**Change Notification #:** 113191 - 00  
**Change Title:** Intel® Server System R2208GZ4GC  
PCN 113191-00, Product Design  
Update Resistors and Capacitors  
**Date of Publication:** August 01, 2014

Intel is implementing the following change on the Intel® Server System R2208GZ4GC:

Table 1: Component Updates for the 2U Riser Spare A2UL8RISER

Figure 1: Component Locations for the 2U Riser Spare A2UL8RISER

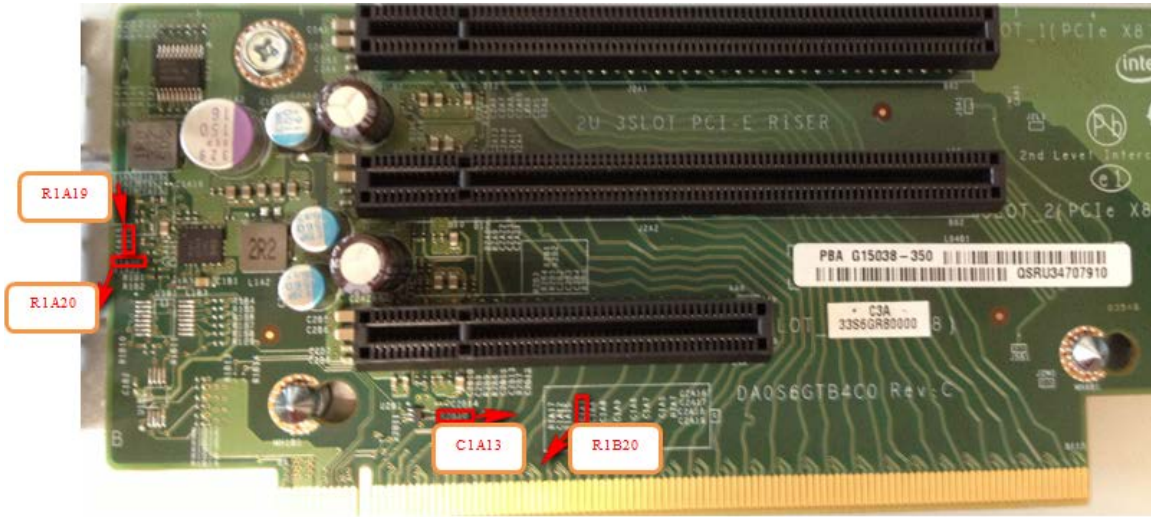
Update the following resistors and capacitor (see Table 1 and Figure 1) on the 2U PCIe Riser Spare A2UL8RISER to make an improvement to support a higher 3.3 Voltage Regulator startup over current. Before this change, the Voltage Regulator on the riser card may not be able to turn on when the total current drawn is more than 5A current. After this change, the Voltage Regulator on the riser card can support more than 10A current.

Component	Location	Pre-change	Post-change
Resistor	R2B10	10.0 kOhm	3.65 kOhm
Resistor	R1A20	0 Ohm	30 Ohm
Resistor	R1A19	40.2 kOhm	20 kOhm
Capacitor	C1A13	10 pF	120 pF
